VILLAGE OF BALLSTON SPA  
HISTORIC DISTRICT COMMISSION  
May 12, 2023 8 AM

Commission members Gary Stephenson, Carrie Chapman, and Steve Springer met at 17 East High Street, with Andrew and Kristina Maas in response to a building permit application dated May 08, 2023 and referred to the Historic District Commission on May 09, 2023.

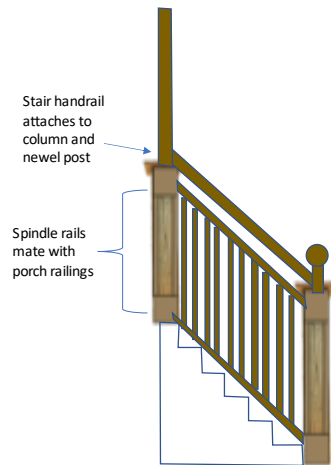
In as much that the applicants had already modified several of the round posts, removing the lower portion and replacing it with a square cross section, the HDC took the position of evaluating the appropriateness of that new design. Noted is that additional moldings are proposed be added to the presently plain square post sections per the photo below:

The proposed style was deemed not inconsistent with the rest of the building. The change was also deemed acceptable given the difficulties of preserving the present railings otherwise, given their rotted ends. The applicants were requested to save with the house long term, representative removed sections along with the base moldings in case the original post configuration should ever want to be restored in the future.

1. That the Commission has no objection to the new porch post treatment.
2. The proposed porch lattice design and attachment method is acceptable.
3. The new porch steps design is approved but the commission requests they remain in a consultative role as the design details are refined.
